SUBJECT: Forwards changes to FSAR, providing consistency between wording in Tech Specs & FSAR, per discussions w/NRC & util consistency review. Changes will be incorporated in future FSAR update.

Re: Nine Mile Point Unit 2
Docket No. 50-410

SUBJECT: Justifications for changes to FSAR Figure 9.5-52C and FSAR Table 11.5-2

FIGURE 9.5-52c
 AUXILIARY BOILER SYSTEM

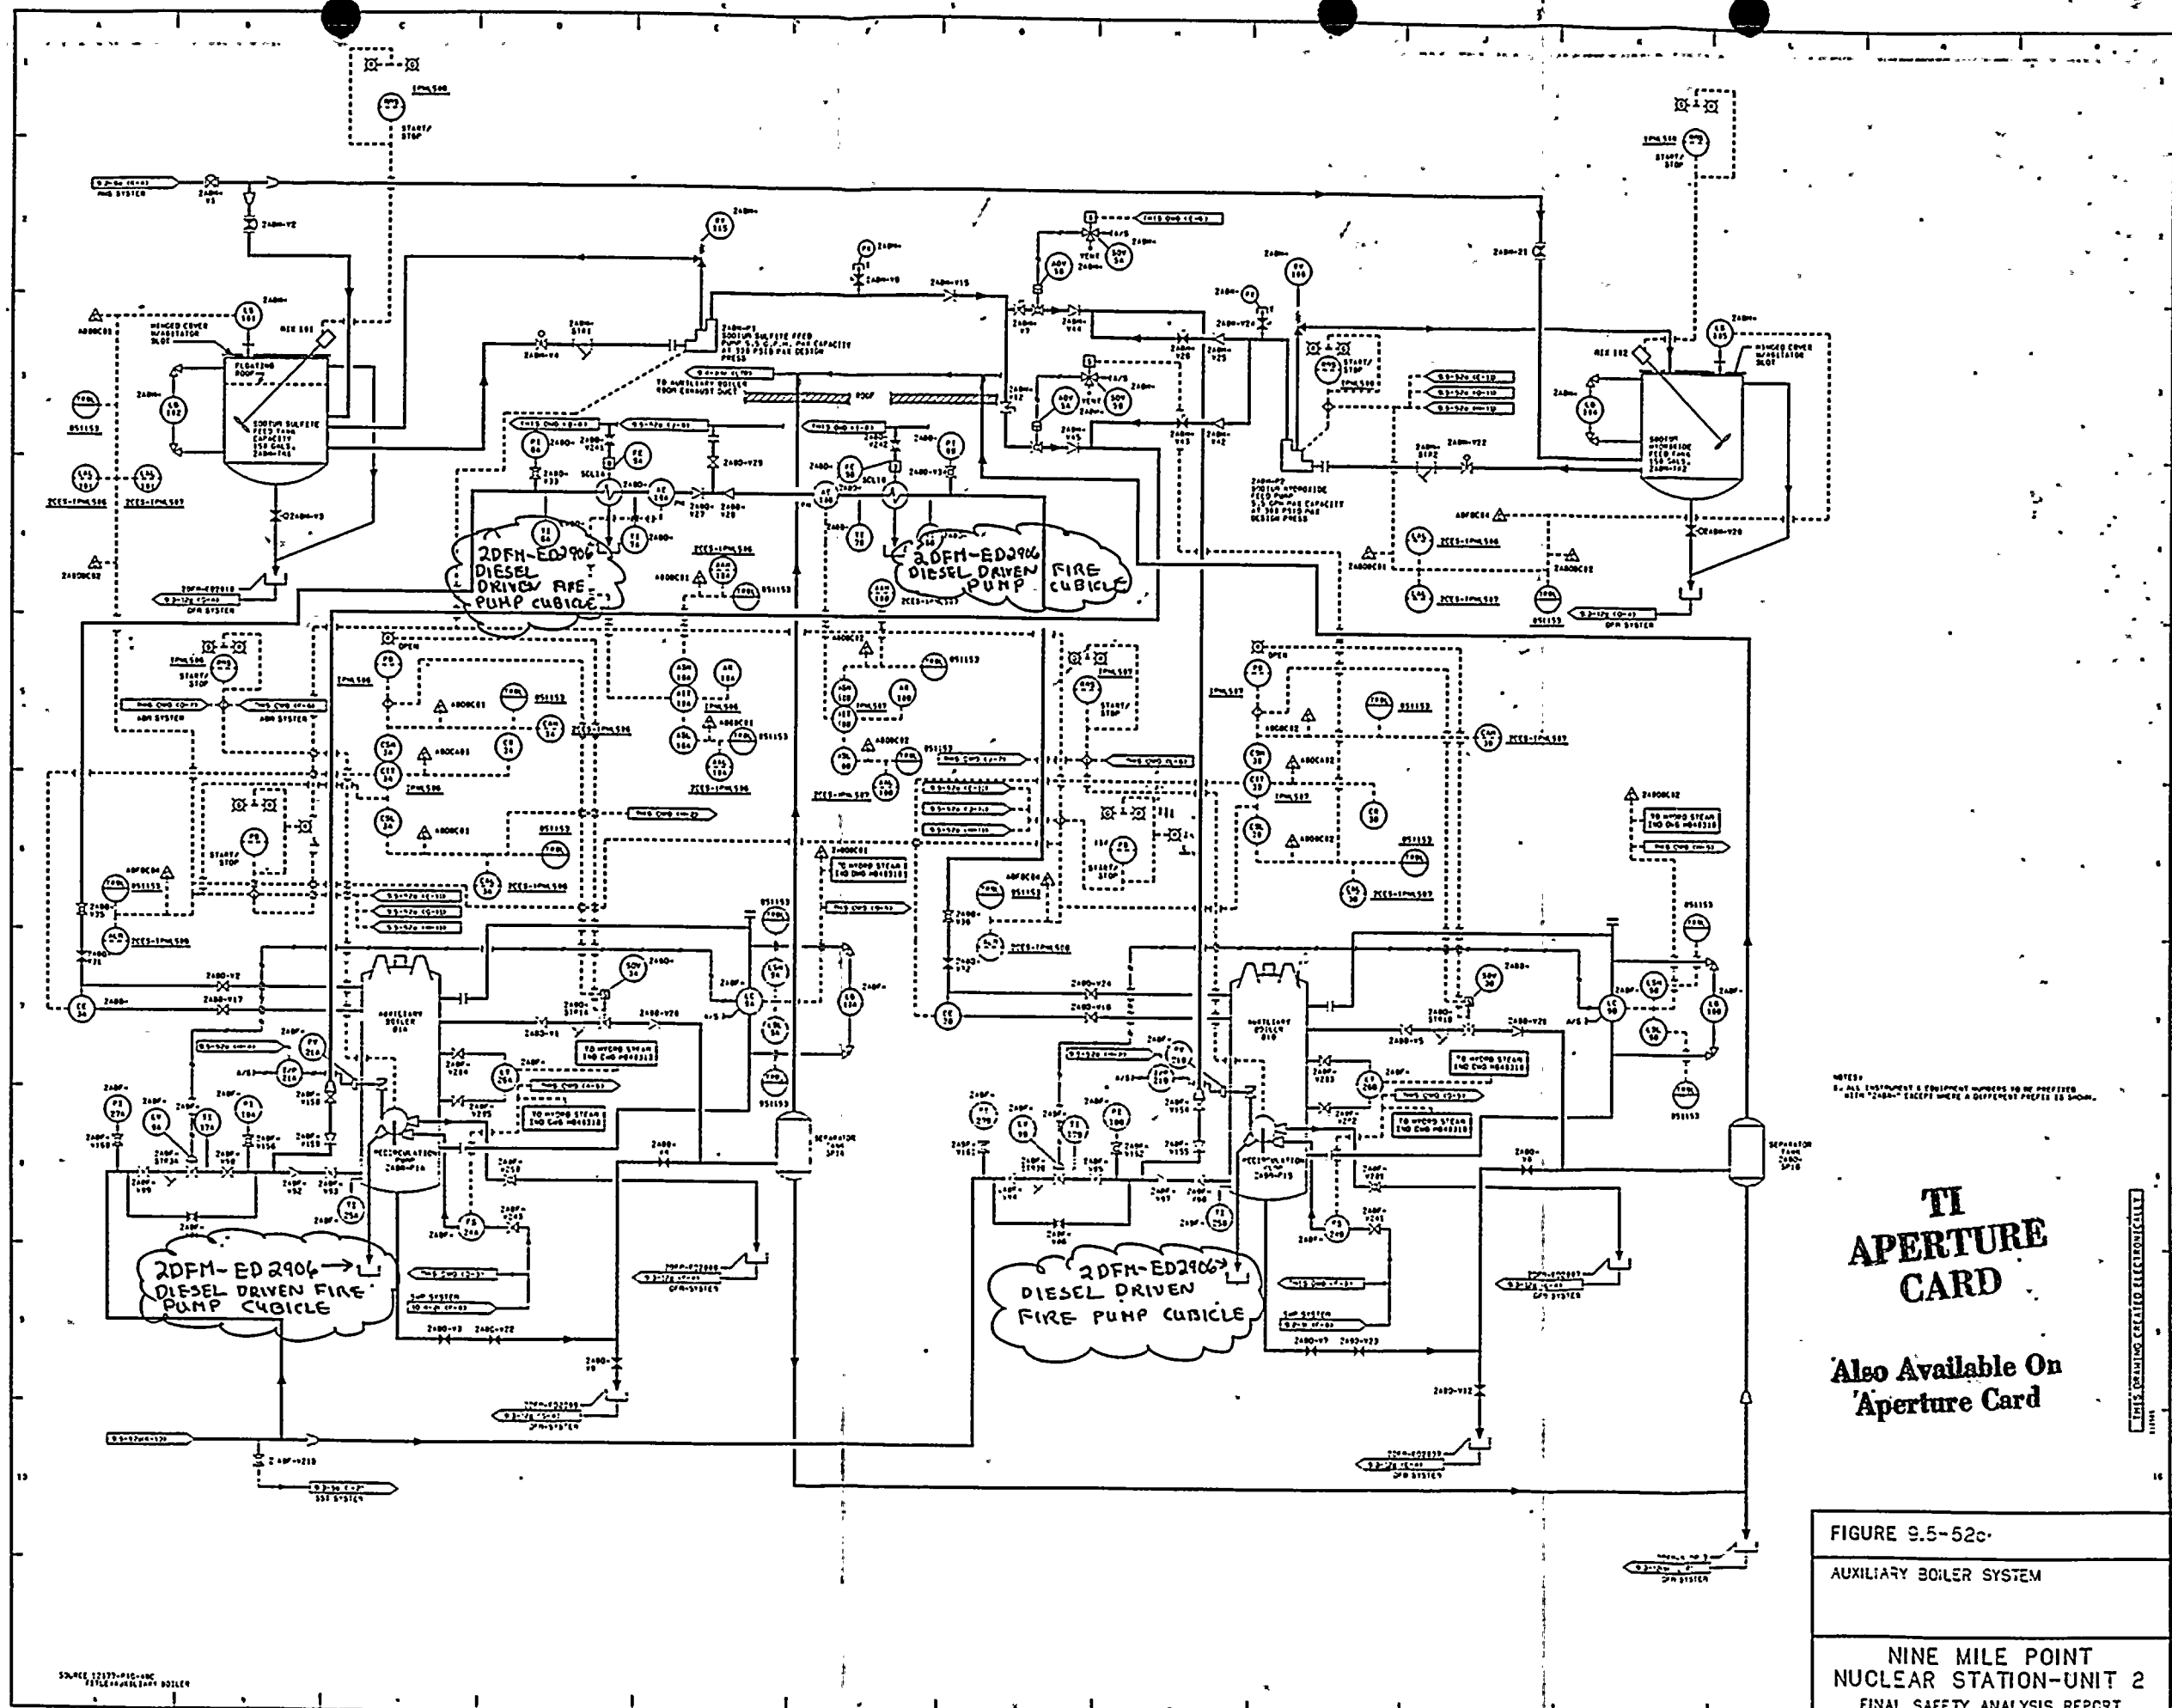
The changes to FSAR Figure 9.5-52C and FSAR Table 11.5-2 are provided in order to make the FSAR consistent with Technical Specification Table 4.11.1, Item 2.d.
